**WATER LEAK IN HEADLINER/DOME LAMP AREA—
VEHICLES EQUIPPED WITH ROOF OPENING PANEL
AND SAFETY CANOPY AIR BAG SYSTEMS—BUILT
BEFORE 3/27/2007**

TSB 07-20-6

FORD:
2006-2007 Explorer

This article supersedes TSB **06-21-17** to update the Part List and Service Procedure.

Figure 1 - Article 07-20-6

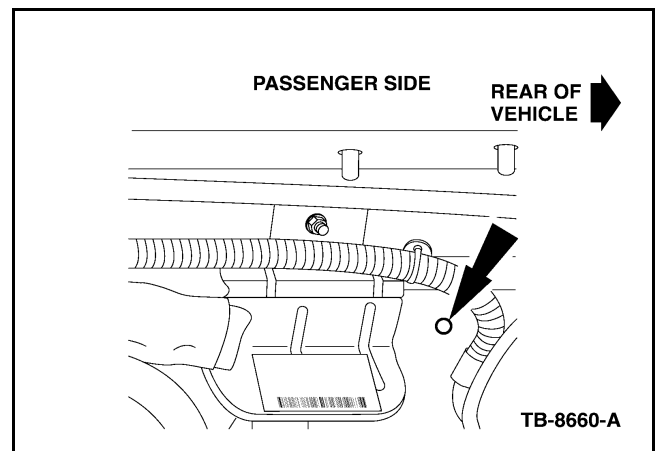
IF A HOLE HAS BEEN DRILLED IN THE LOWER REAR CORNER OF THE RECTANGLE BRACKET (FIGURE 1) GO TO STEP 5. IF THE VEHICLE WAS BUILT AFTER 8/14/2006 DRILLING A 1/4" HOLE IS NOT REQUIRED.

3. Drill a 1/4" (6.7 mm) hole, 3/4" (20 mm) rearward from the lower rear corner of the rectangle. (Figure 1)

Figure 2 - Article 07-20-6

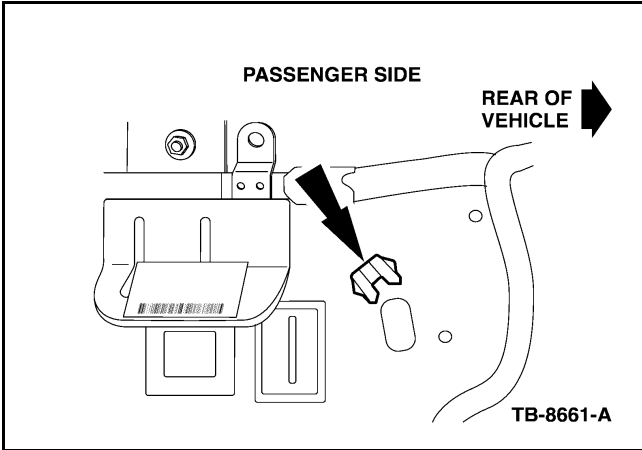
4. Remove the rear drain tube. Attach hose clip to existing hole for vehicle built after 8/14/2006. For all other vehicles attach the hose clip in the new hole. (Figure 2)

Figure 3 - Article 07-20-6

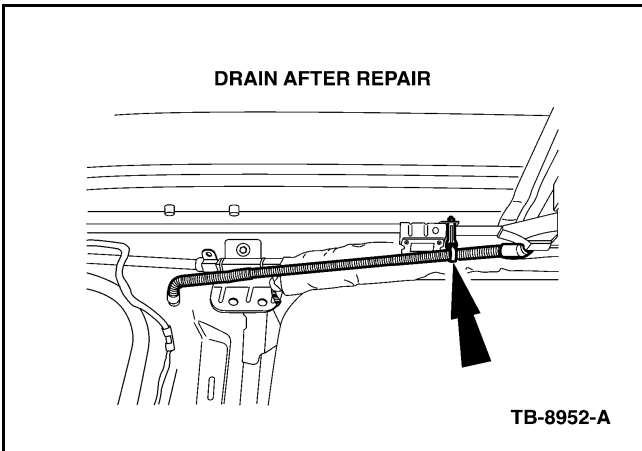
5. Install the updated drain tube.
6. Attach the hose clip to the coat hook support bracket. (Figure 3)

Make sure the drain hose is placed under the coat hook bracket. (Figure 3)

7. Make sure there is no slack left in the hose as it leads up to the roof opening panel module. (Figure 3)
8. Repeat procedure on opposite side.
9. Install headliner following WSM, Section 501-05.
